HR 14-10 New Single Family Residential in the Canemah National Register District

File #: PC 15-158, Version: 1

Requesting approval for change of material from original approved design and recommending adaption into material used in the single family residential homes in the Canemah National Register District.

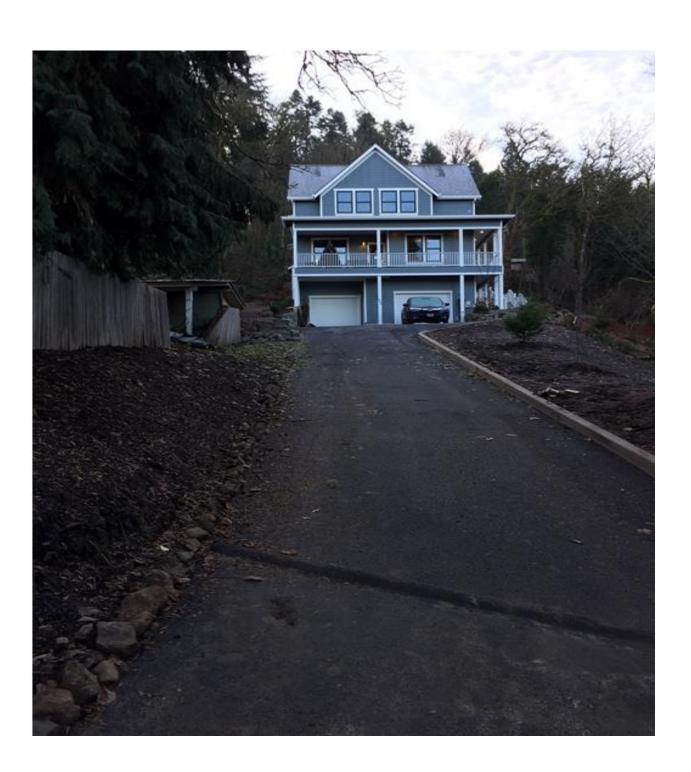
In accordance with condition # 5 "Incised lumber or pressure treated wood shall not be used on any visible surfaces". The underside of the deck was visible from 4th street so we believe it needed to be covered under our interpretation (this was not part of the original design). Before this change, the Lumber supplier, Siding Company, Contractor and Architect had concern of air flow in the trapped area which could cause premature wood decay and mold build up on the designed and approved material. All suppliers recommended Trex deck to be used instead of the "traffic topping" over marine grade plywood. The Trex decking selected was special ordered so it resembled 2 x 6 boards with no groves for clips and would be screwed like normal wood boards when viewed up close.

No Trex was used on visible surfaces from the street plane view, Stairs and stair landings visible from the street plane view used a wood 2 x 6 board surface.
